LEGE
 SITE GRADING & DEVELOPMENT WORK
 SITE GRADING & STORM DRAINAGE PLAN
 DATE JULY 7, 1969
 DRAWN 6676
 DWG. NO. **56-16**
 JOB NO. 67-1-M

SOLANO COUNTY JUNIOR COLLEGE
 SOLANO COUNTY JUNIOR COLLEGE DISTRICT
 ARCHITECT OWNER CONTRACTOR

SITE GRADING & DEVELOPMENT WORK
SITE GRADING & STORM DRAINAGE PLAN

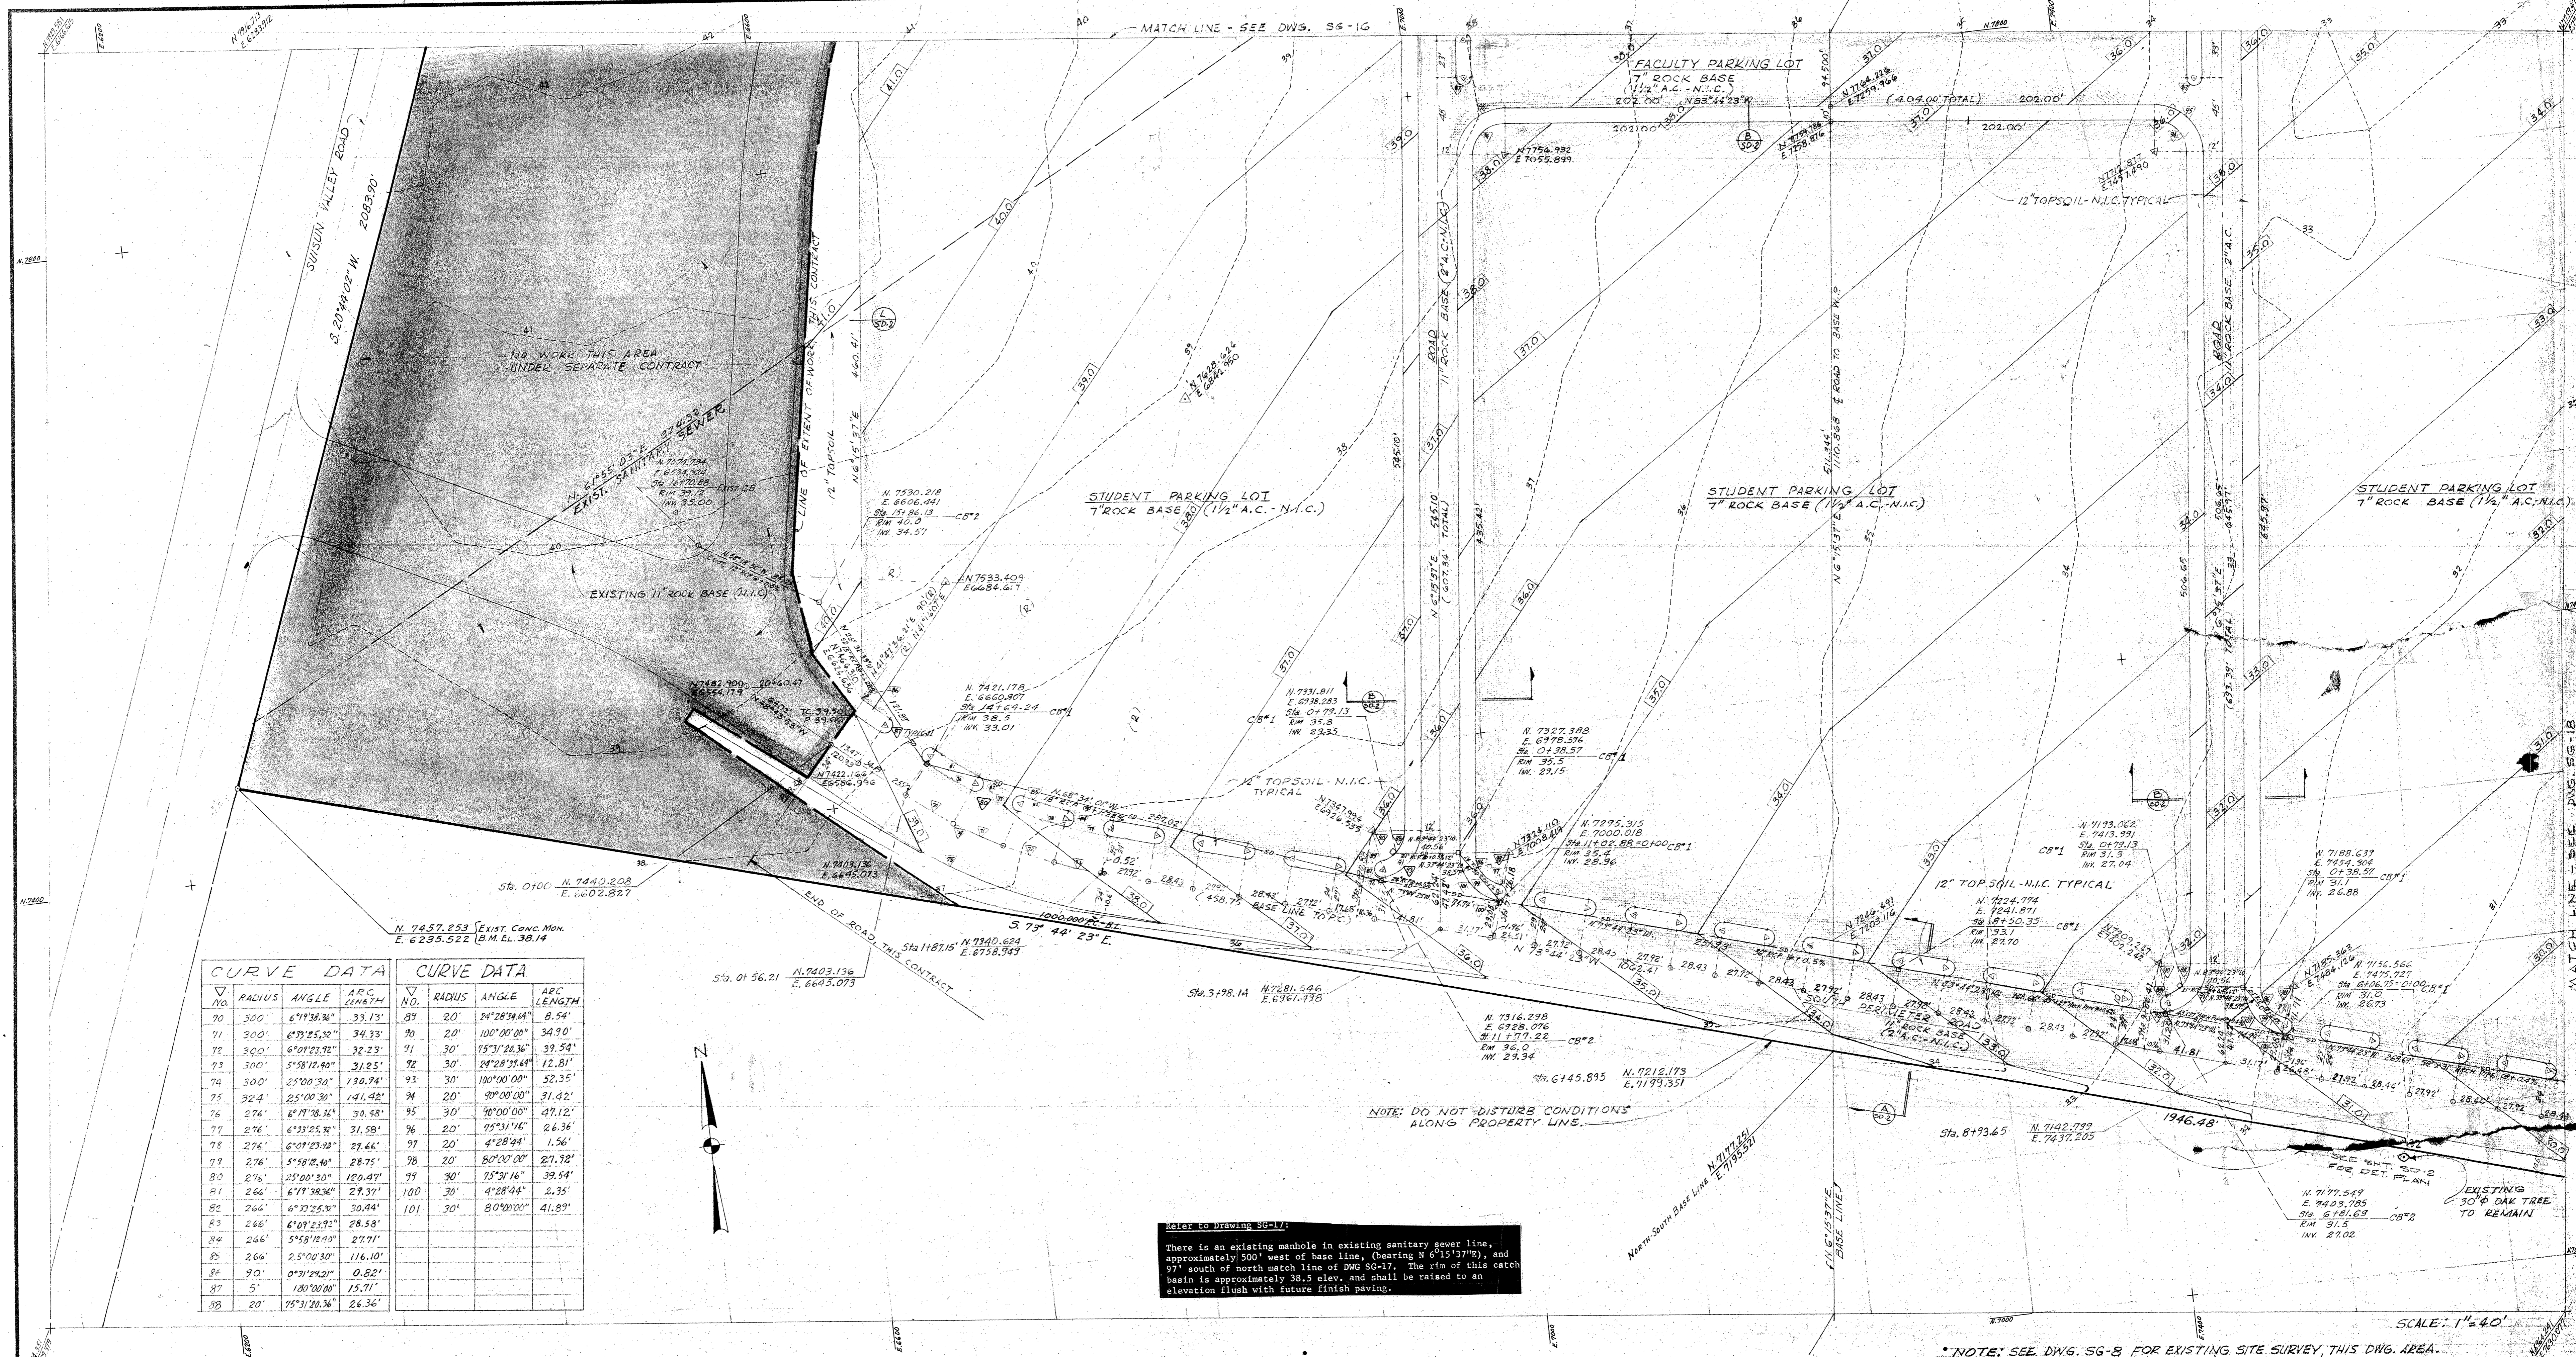
SOLANO
 SOLANO CO
 ARCHITECT
 Refer to Drawings SG-1 and SG-16:
 There is an area approximately 35' x 40' south of buildings 300 and 400, and south of the east west line having a bearing of N83° 30' 00"W. This area is shown to be not in contract. This area shall be changed to be included in the contract. Grade to finish grades shown on SG-16, and take all precautions to protect existing utilities and fire hydrants.

DATE JULY 7, 1969
 DRAWN 6/2/69
 DWG. NO. **SG-17**
 JOB NO. 67-1-M

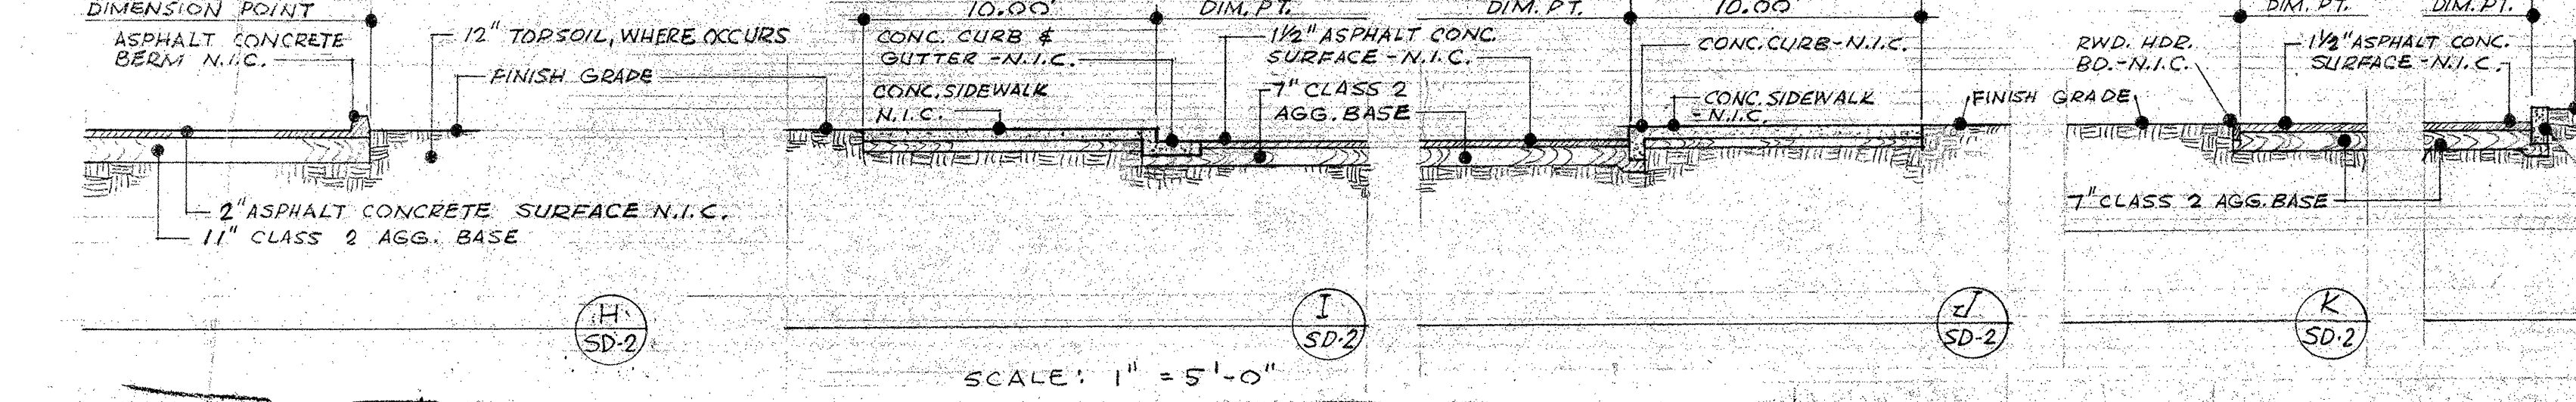
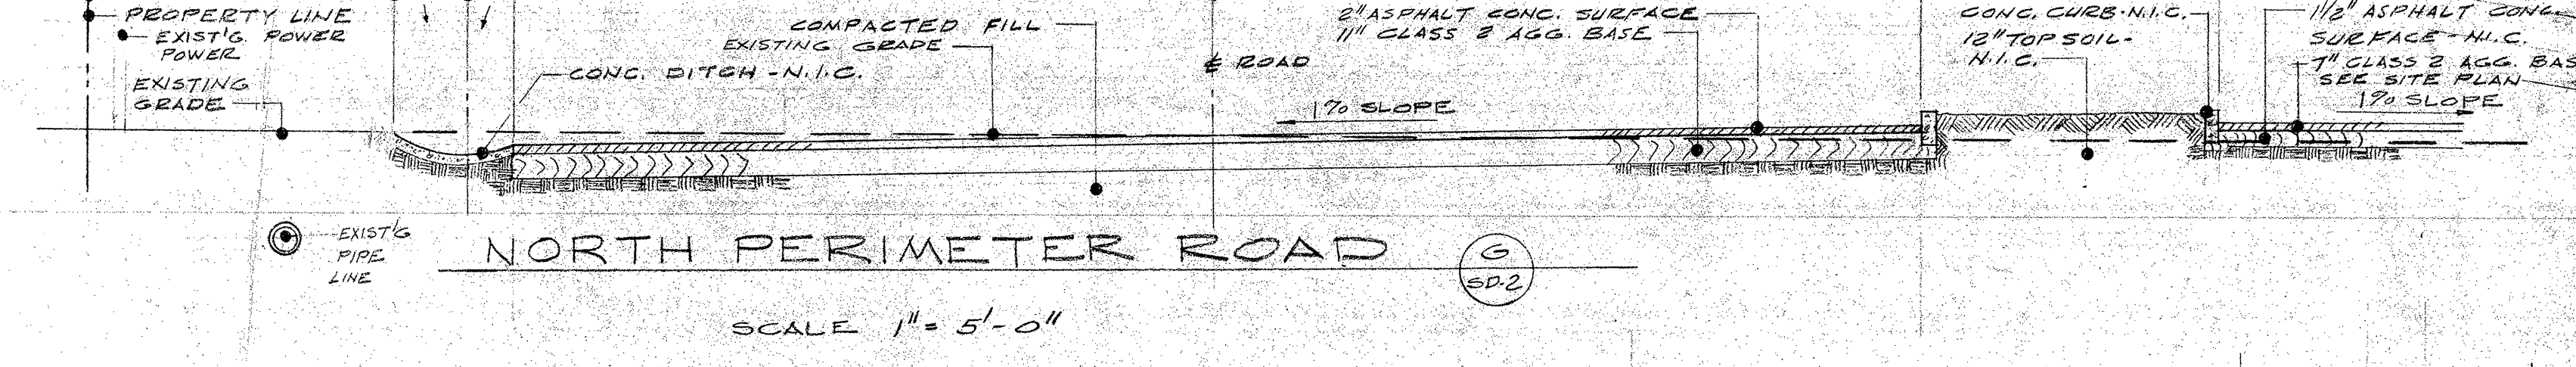
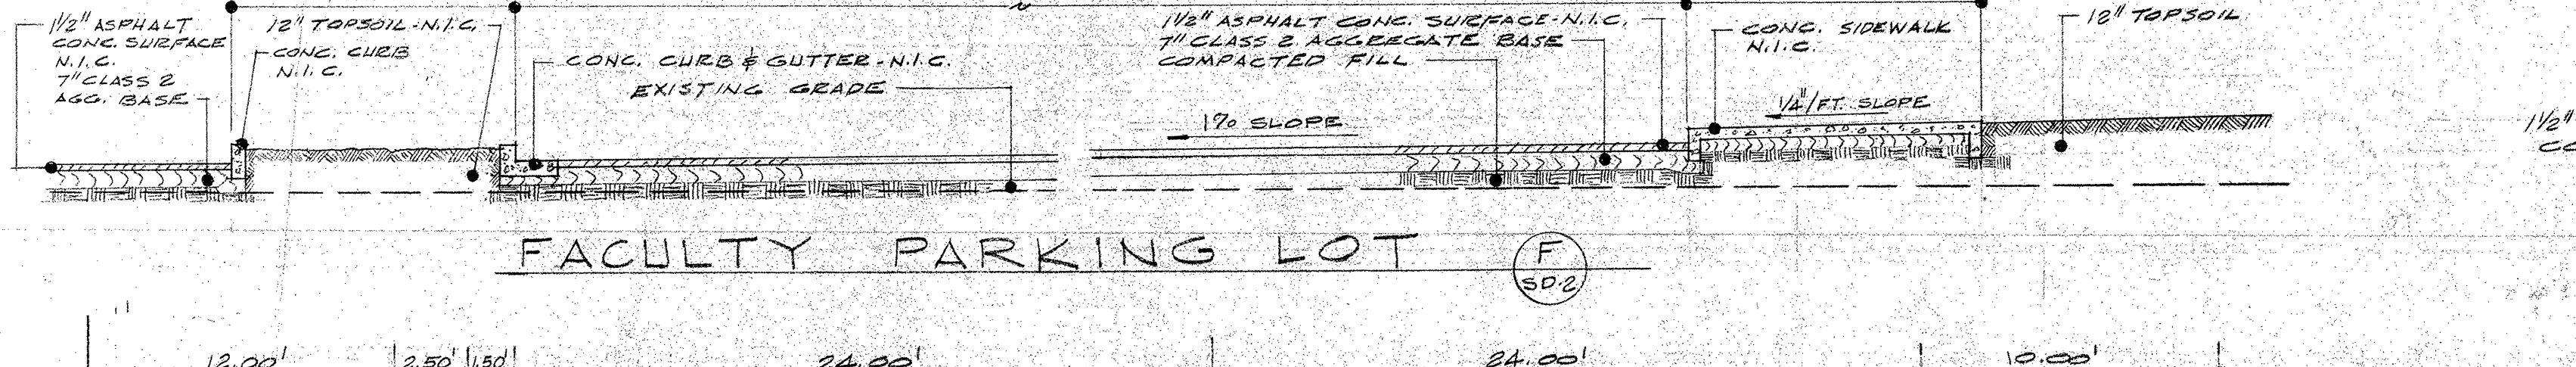
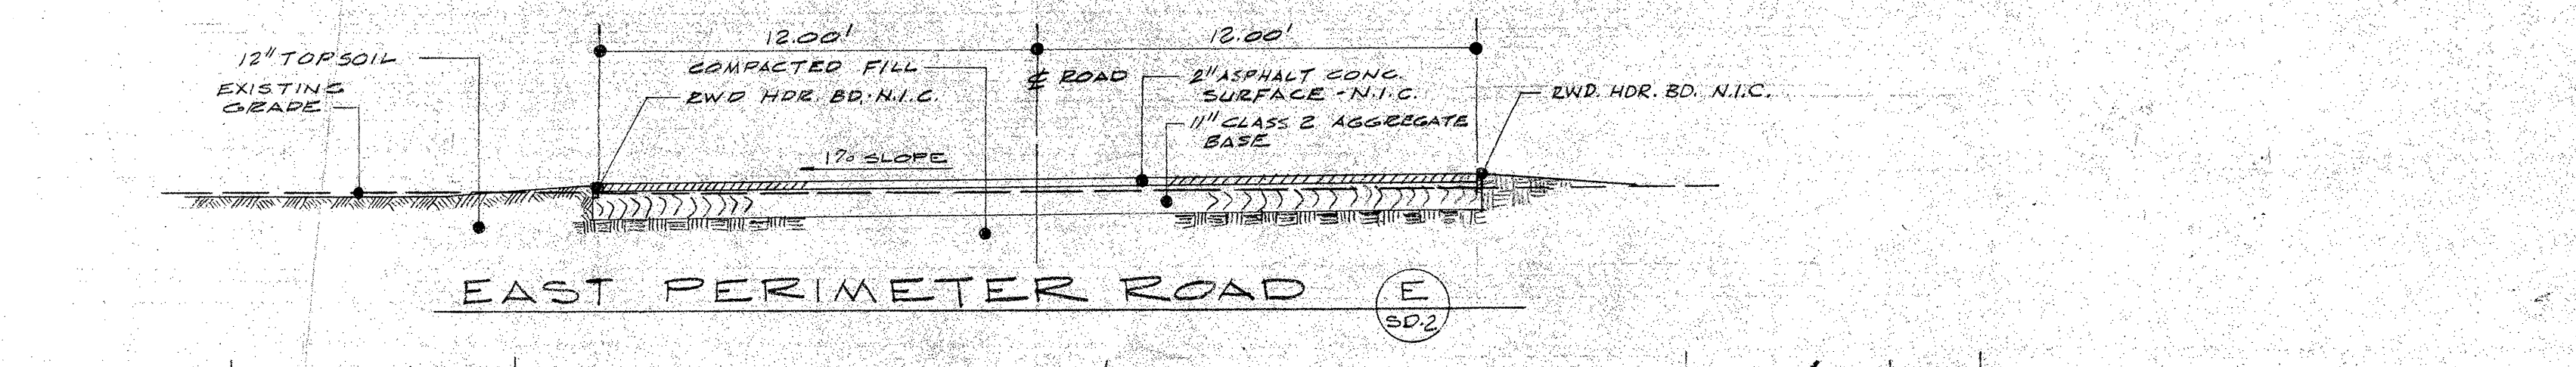
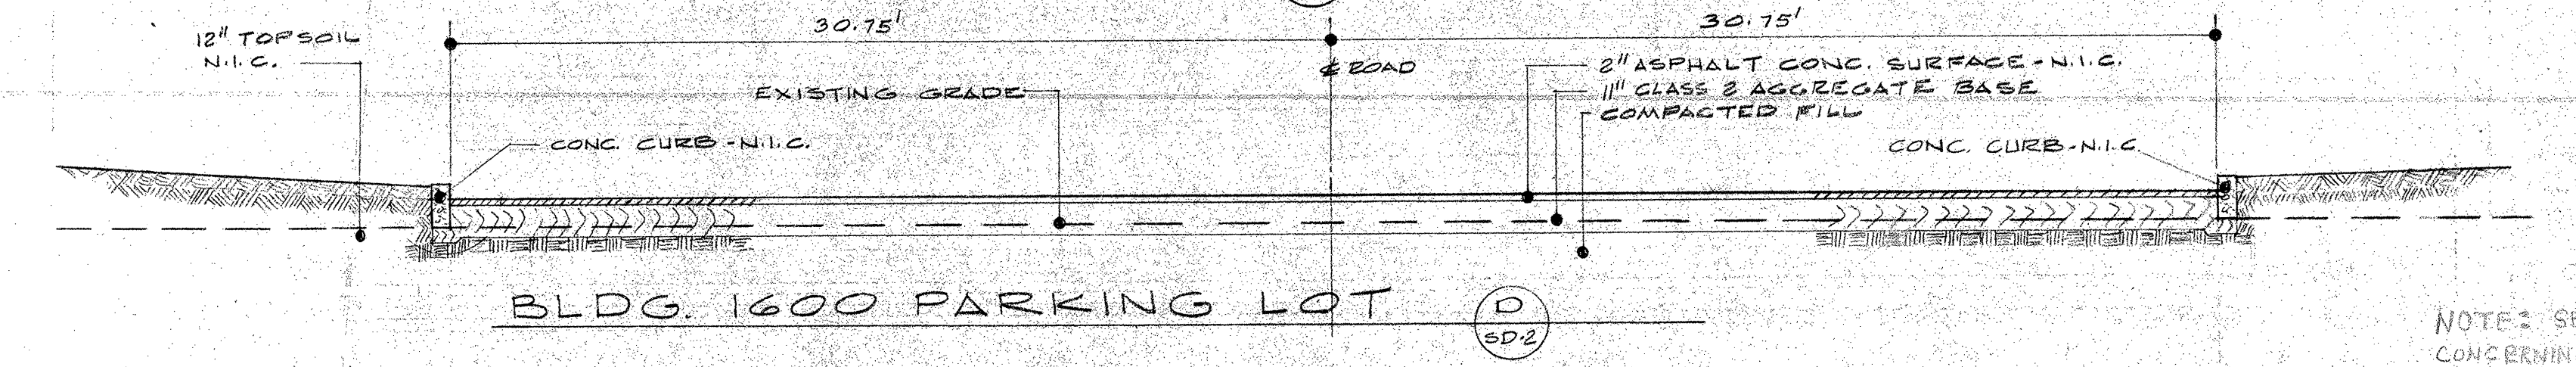
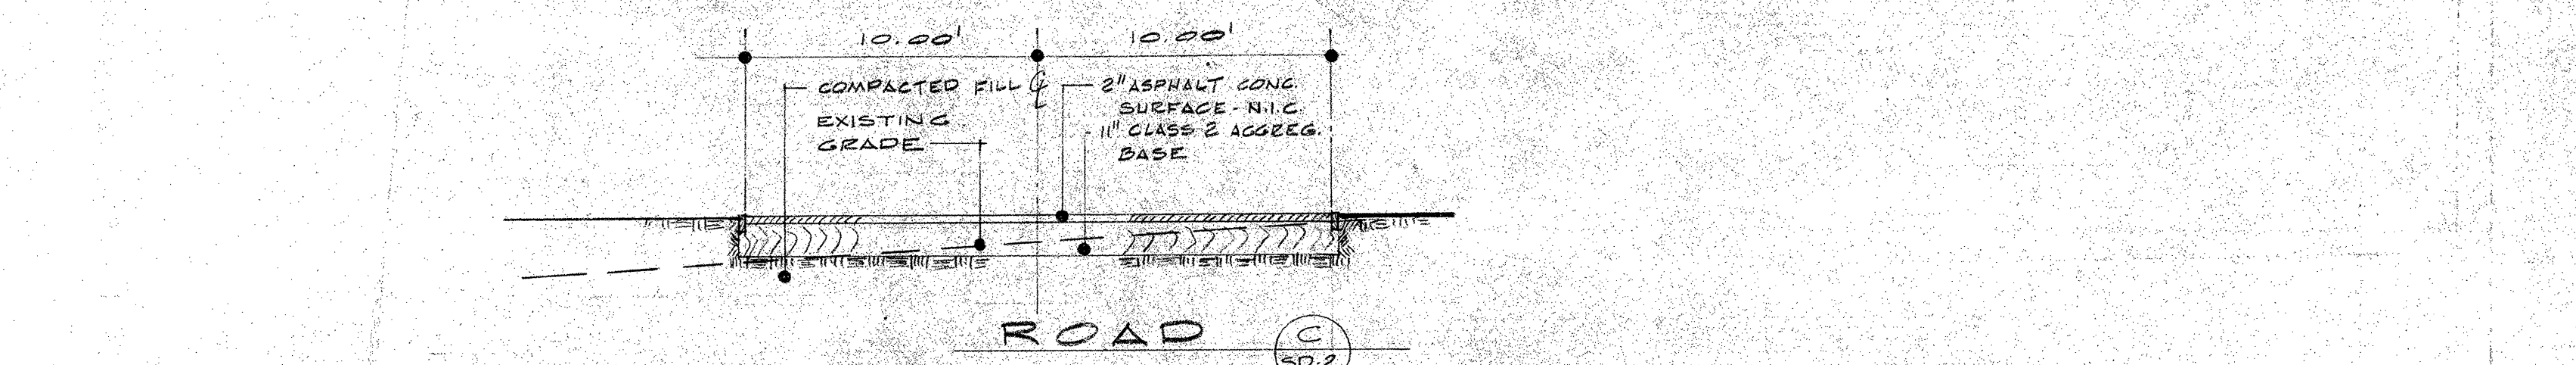
Refer to Drawing SG-17:
 There is an existing manhole in existing sanitary sewer line, approximately 500' west of base line, (bearing N 6°15'37.78"), and 97' south of north match line of DWG SG-17. The rim of this catch basin is approximately 38.5 elev. and shall be raised to an elevation flush with future finish paving.
